**Amended shop-top housing development (DA-482/2017), 59-75 Grafton Street, Bondi Junction**  
**ADDITIONAL INFORMATION: OVERSHADOWING**

This letter considers the overshadowing impact of the Section 4.55(2) proposal as previously submitted to Council (November 2020) and describes proposed amendments that will ensure that the modification application complies with the relevant Apartment Design Guide (**ADG**) overshadowing objective and design guidance.

**Figure 1: Level 18 comparison**

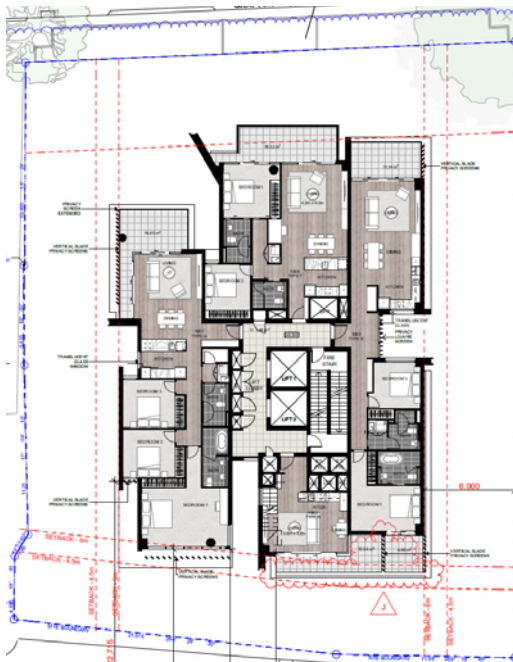
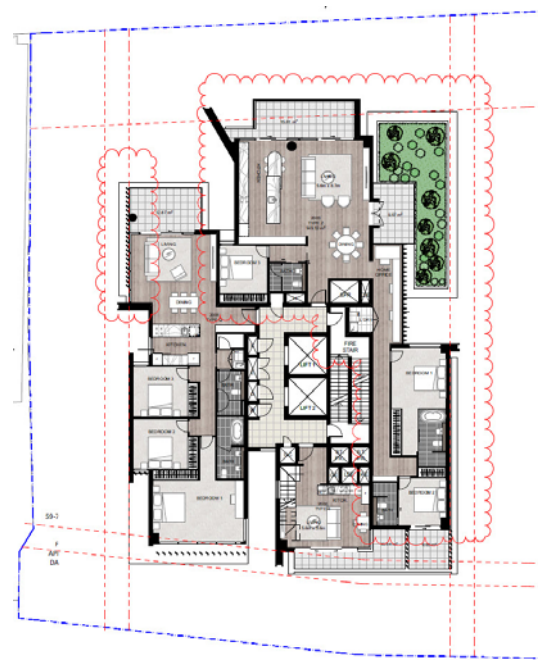
- Reduced footprint in the north-east corner and replanning of apartments (reduction of two units)
- Replanning of the rooftop communal open space and roof above to retain the area and amenity of the communal area.

The comparison plans illustrate the significant reduction in building footprint in the north-east corner of the proposed additional levels.
